David Wilson Homes

Response to WBC Highways

SLR Project No.: 184395

24 November 2025

PROJECT: Ducks Nest, Wokingham		CLIENT: David Wilson Homes (Southern	
DRAWING TITLE: SWEPT PATH ANALYSIS TRACTOR & TRAILER - OUTBOUND PASSING CAR - INBOUND			
DRAWN: SCJ	CHECKED: SCJ	DATE: 20.11.25	SCALES: 1:500 @ A3
DRAWING NUMBER: 184395_PD14_AT02			REVISION: -

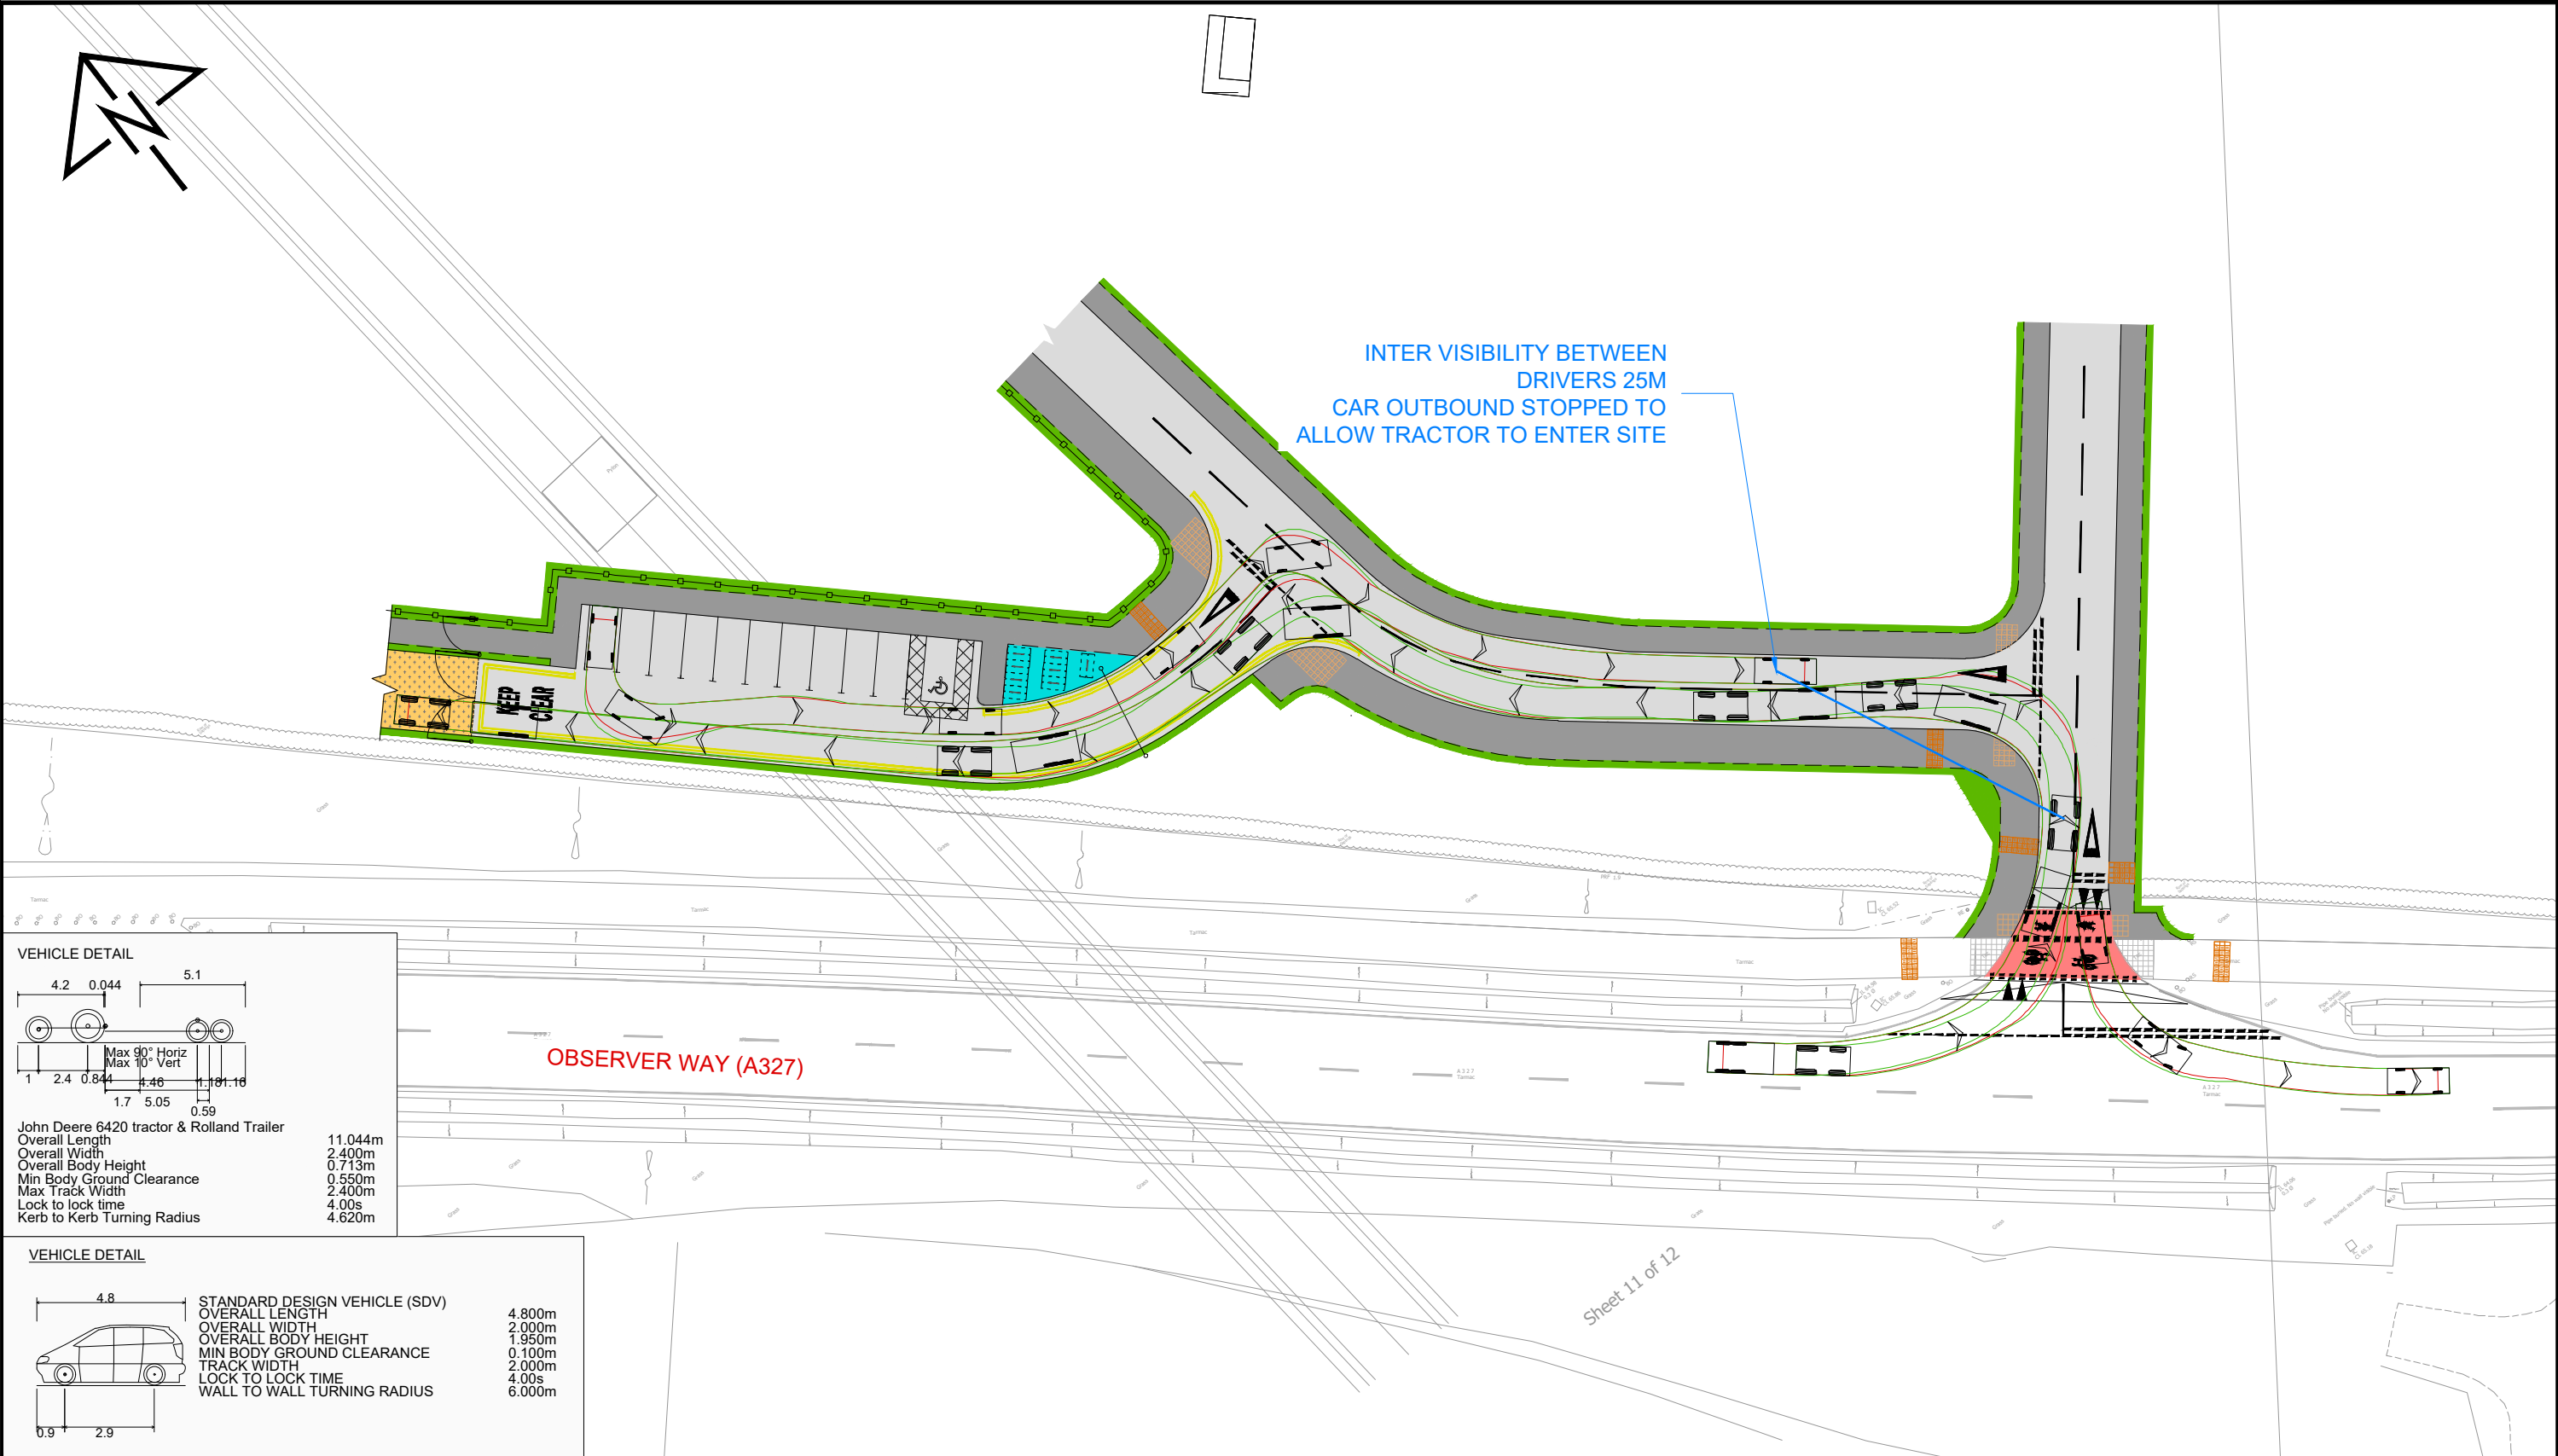
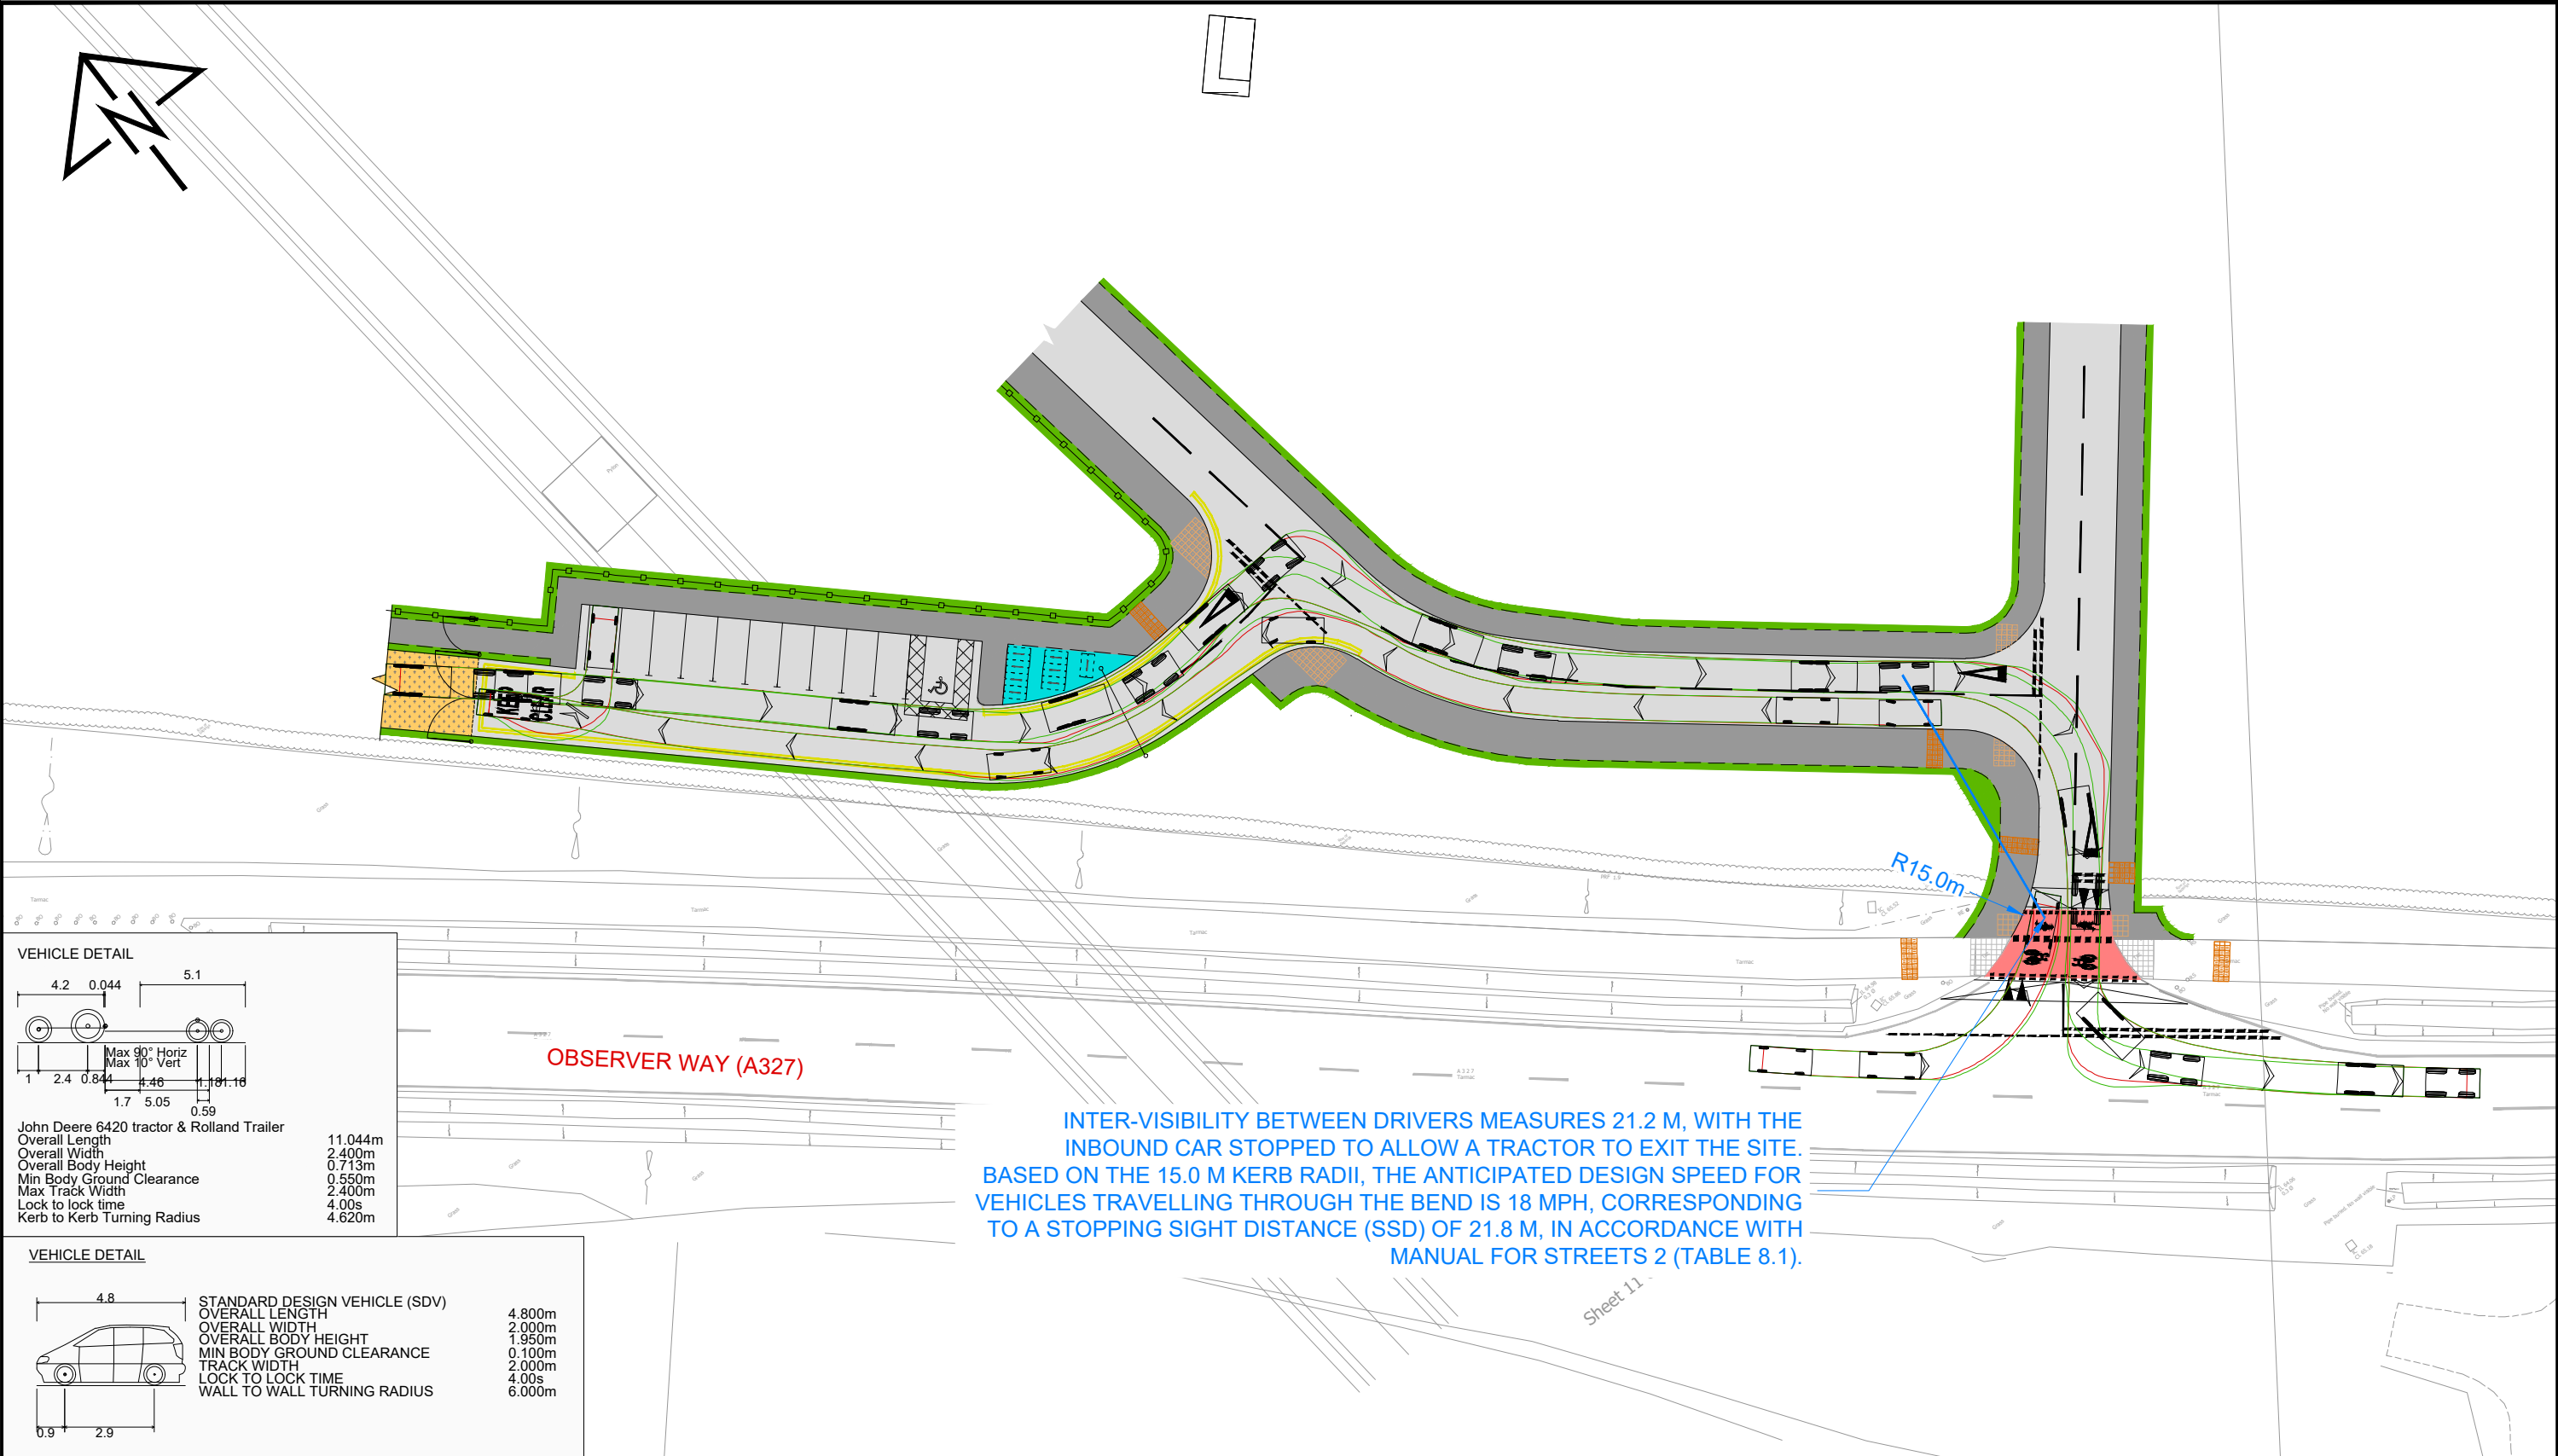
44. Paragraph 44 suggests that the vehicle swept path should be updated to higher speeds, despite recognising that it is reasonable to expect larger vehicles to travel at lower speeds and overrun the central island. However, this request is inconsistent with both the purpose of the software and published guidance³ given that swept path analysis models the envelope of vehicle movement the maximum space required to complete a manoeuvre based on vehicle geometry, steering geometry, overhangs, and turning radii. It does not simulate the precise trajectory that an individual driver may take at a fixed speed. The submitted tracking demonstrates that the design vehicles can negotiate the layout safely. It is entirely expected and permitted under DMRB and MfS guidance that larger vehicles will make use of overrun areas or adjust speed to navigate without conflict. In addition, there is no reference or requirement within DMRB or MfS to model tracking at a specified vehicle speed and therefore it is not considered necessary to update the submitted tracking.

80. Paragraphs 80 and 81 relate to the SANG access and parking arrangements. The requests for additional swept path and amendments to the parking space dimensions are noted and included at **Appendix B**.

INTER-VISIBILITY BETWEEN DRIVERS MEASURES 21.2 M, WITH THE INBOUND CAR STOPPED TO ALLOW A TRACTOR TO EXIT THE SITE. BASED ON THE 15.0 M KERB RADII, THE ANTICIPATED DESIGN SPEED FOR VEHICLES TRAVELLING THROUGH THE BEND IS 18 MPH, CORRESPONDING TO A STOPPING SIGHT DISTANCE (SSD) OF 21.8 M, IN ACCORDANCE WITH MANUAL FOR STREETS 2 (TABLE 8.1).
